TECHNICAL BULLETIN – Notice of Potential Carbon Monoxide Hazard:

Boiler Series: NTI-Matrix
Boiler Model: M100, M100V
Boiler Serial Number: 47645 to 51248
Bulletin ID: P/N 85064

**85064: Mandatory
Matrix Flue Adapter Upgrade**

Figure 1 – Matrix Flue Adapter

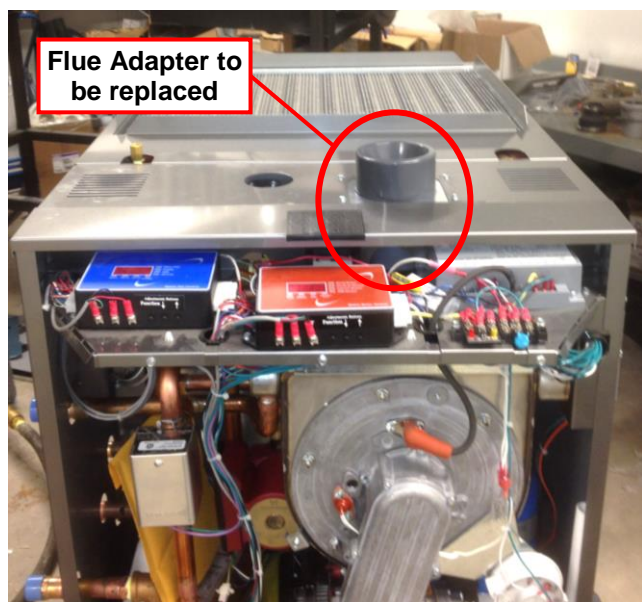
NTI-Matrix boiler models M100 and M100V, with a serial number of 47645 to 51248, must have the Flue Adapter replaced due to a potential flue gas leak and **CARBON MONOXIDE HAZARD**. Figure 1 below, identifies the location of the Matrix Flue Adapter.

Contact NY Thermal Inc. (NTI) immediately for your free Flue Adapter Assembly Kit (P/N 83291-3); identified in Figure 2. Do not operate the appliance until you have installed the replacement kit and you have confirmed there are no leaks in the venting system.
